00 91 01 ADDENDUM #1

Owner: Cobb County-Marietta Water Authority
Project: West Side Loop Section 2, 36" Water Main Replacement
Project No.: 505-9005-10-18-0000/CBR18213
Addendum No. 1
Addendum Date: March 27, 2018

DETAIL CONNECTION #3
STA 95+91±

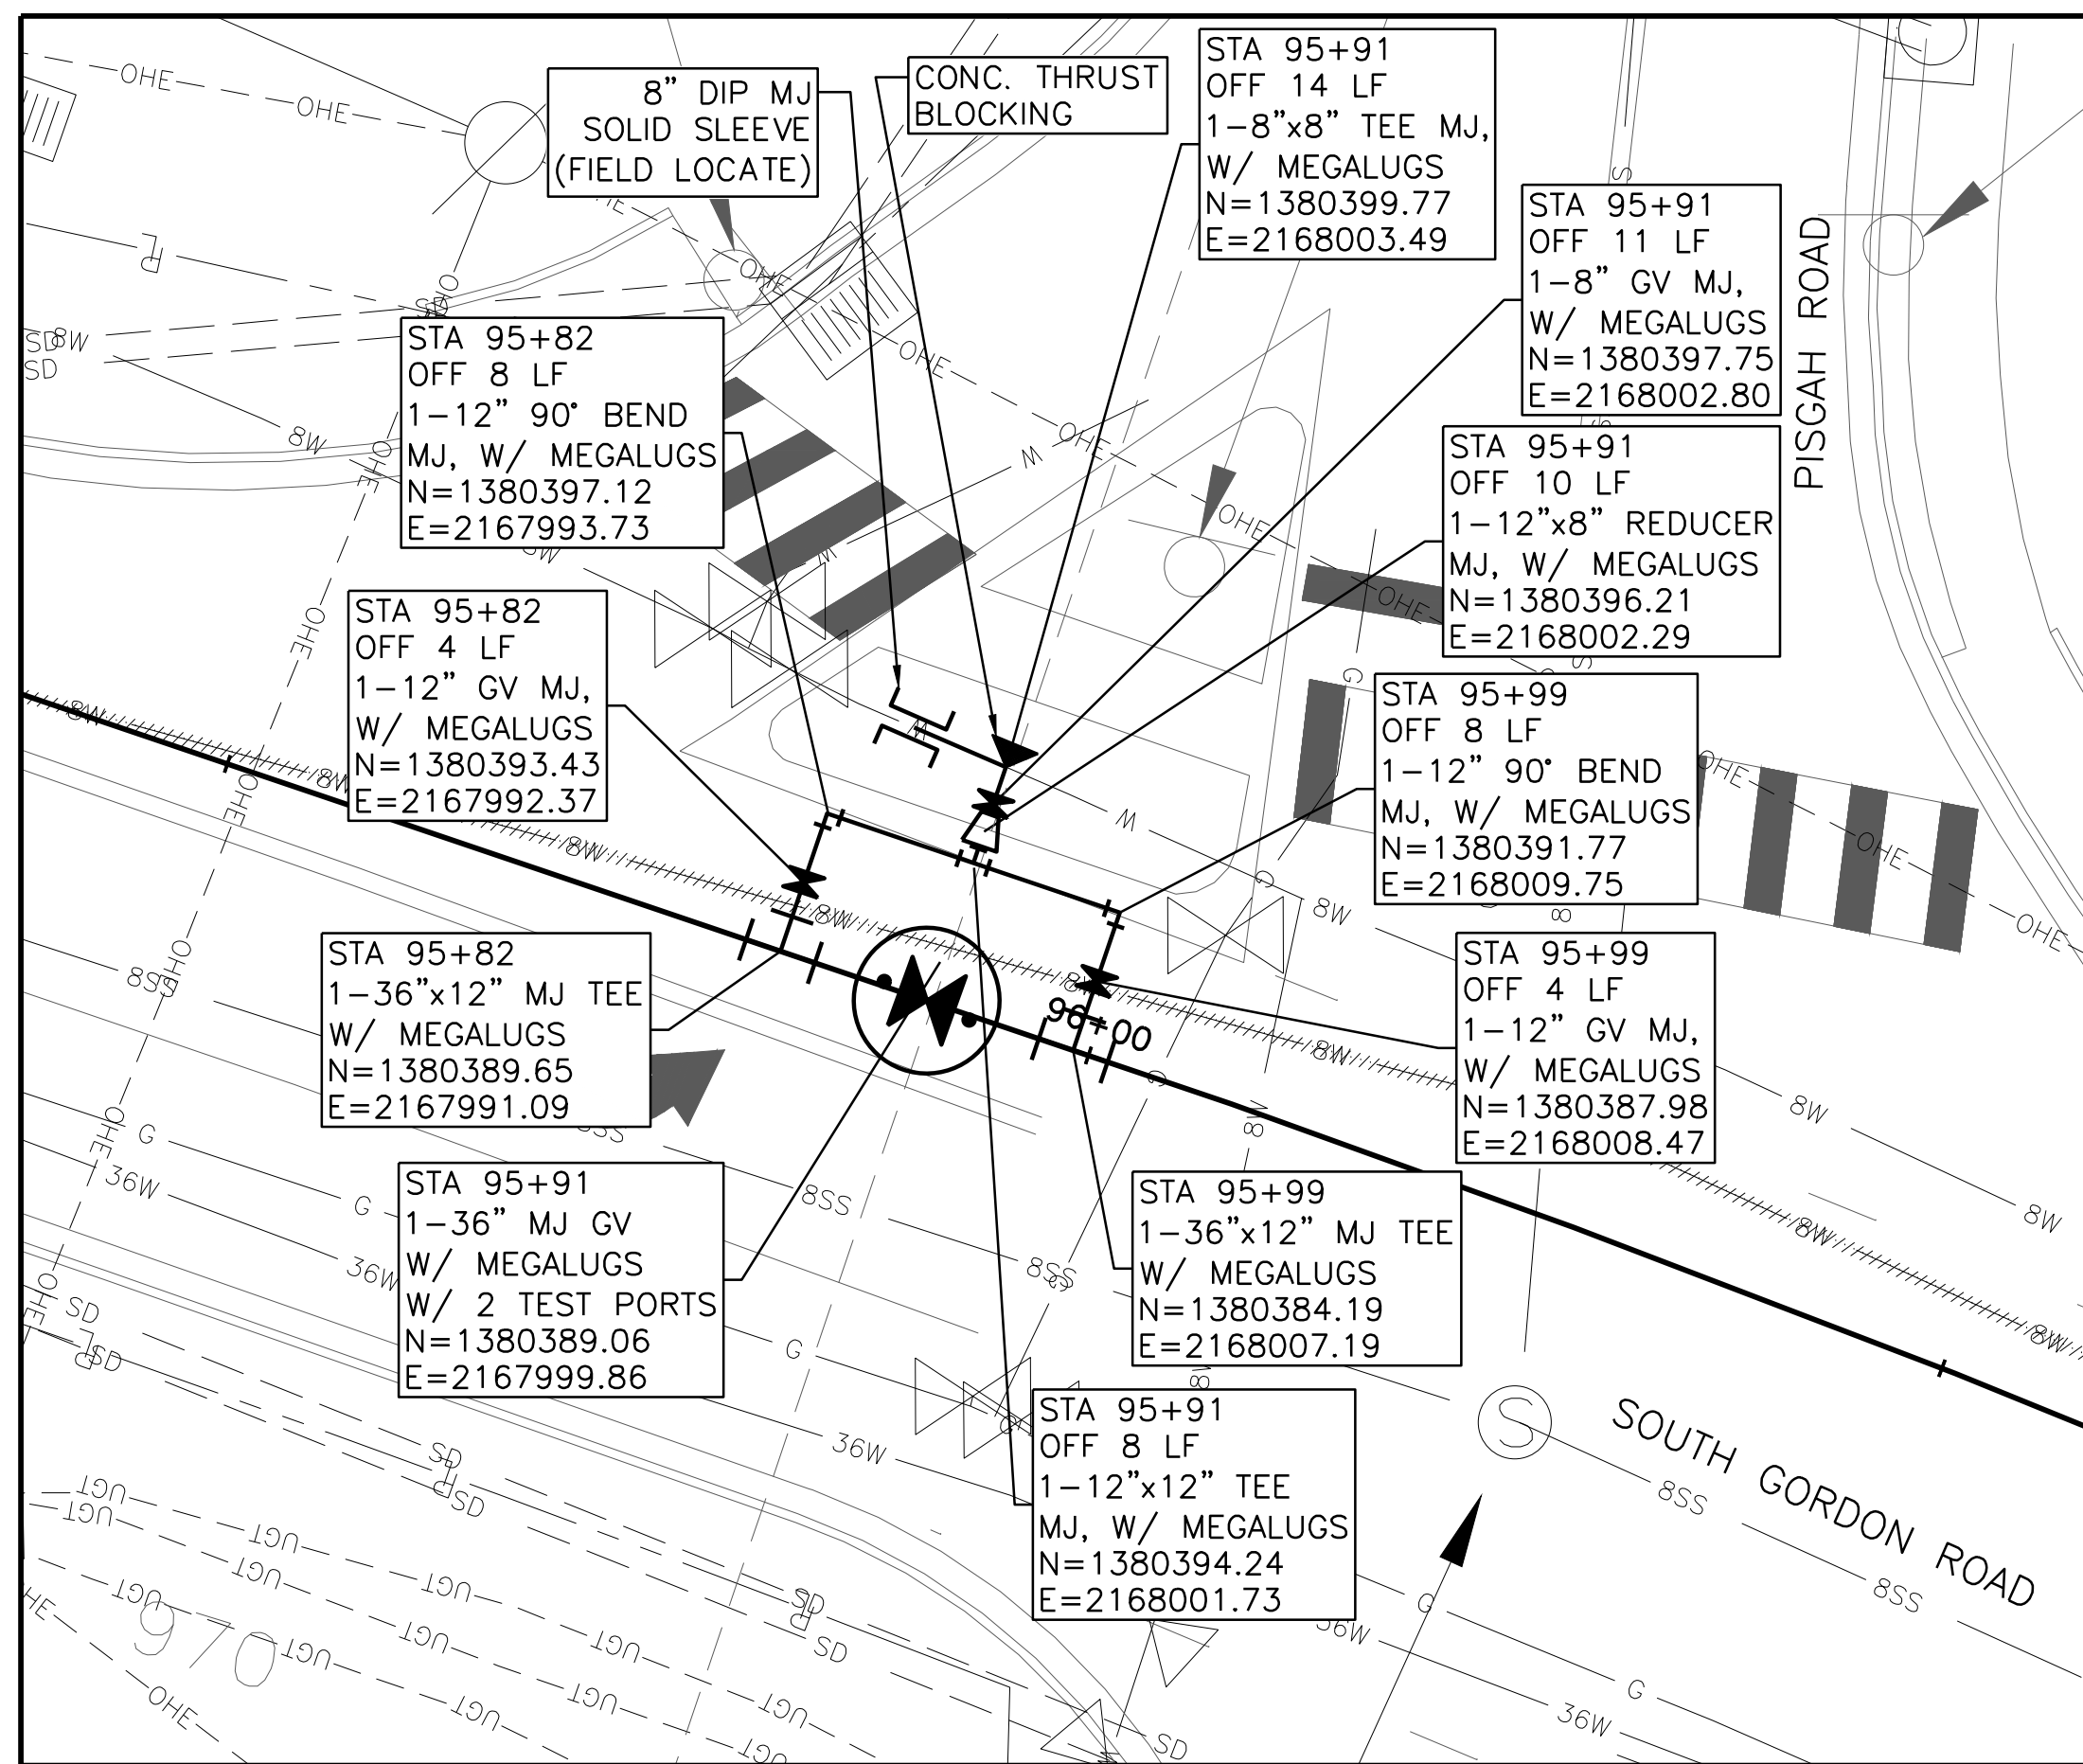
4.02 Sheet C-14 – Plan and Profile STA 92+00 to 99+00

A. Revision: Revise the detail callout for the connection at STA 95+91 to reference Sheet C-32.
